The Sizewell C Project

6.3 Ch Volume 2 Main Development Site Chapter 22 Marine Ecology and Fisheries

Appendix 220 Eels Regulations Compliance Assessment Addendum

September 2021

Figure 3-1: Location of SZB and Proposed SZC WCS Intake and Outfall Heads

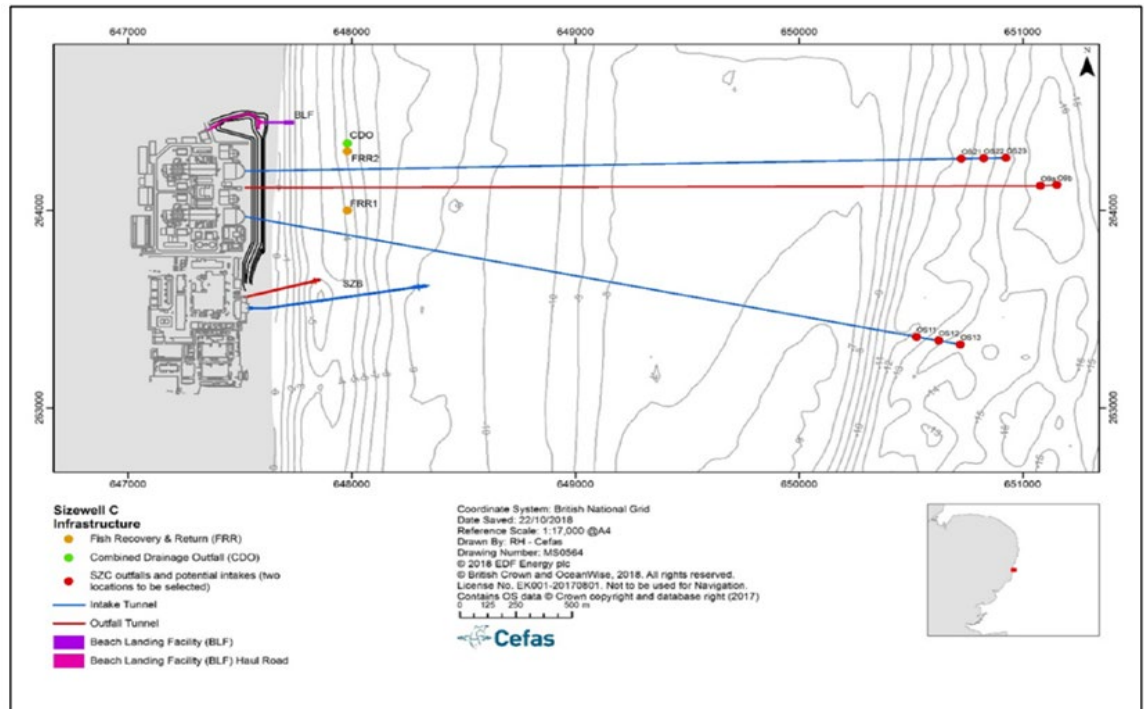
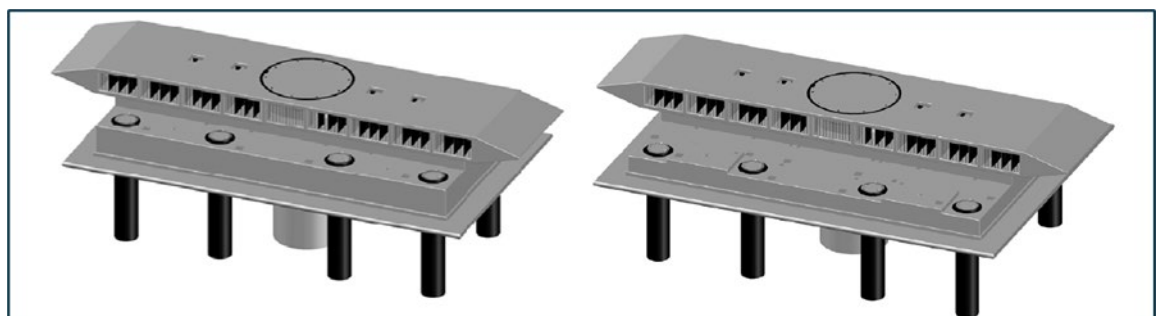
- 3.2.1 The Environment Agency noted in their relevant representation (see Table 1:1) that it is not able to conclude that LSVE heads will provide any mitigation for glass eel entrapment.. BEEMS Scientific Position Paper SPP99 – Predicted impingement performance of the Sizewell C LVSE intake heads compared with the Sizewell B intakes. However, this paper is summarised and presented in **Section 3.3**, along with other supporting additional information.

- 3.3.1 The proposed Sizewell C cooling water system (CWS) intakes will be low velocity side entry (LVSE) structures. A total of four LVSE heads will be installed with two heads fitted on each of the two intake tunnels. The intake heads will be located approximately 3 km offshore, on the eastern side of the Sizewell-Dunwich Bank in approximately 15 m (ODN) depth (Figure 3-1).
- 3.3.2 The LVSE structures are state-of-the-art intakes which are specifically designed to reduce the cross-sectional area available to intercept any European eel being transported in the tidal flows, including all life stages. The reduction in cross-sectional area combined with their low intake velocity is predicted to substantially reduce the number of eel abstracted per cumec (cubic metre per second) of seawater compared with Sizewell B (SZB) which is fitted with two capped omnidirectional intake heads with

intake velocities that exceed the ability of most eels to avoid being abstracted (see Figure 3-2 for 3D images of the HPC LSVE intakes).

3.3.3 SZC Co maintains its position that the LVSE intake head will provide some inquantifiable mitigation of abstraction of glass eels. However, based on detailed discussion at the Hinkley Point C Water Discharge Activity Permit Appeal, SZC Co has agreed to the same concession made by HPC Co (NNB Generation Company (HPC) Ltd) that for the purposes of impact

impingement assessments the LVSE intake head will provide no additional benefit over a typical ‘capped’ intake head.
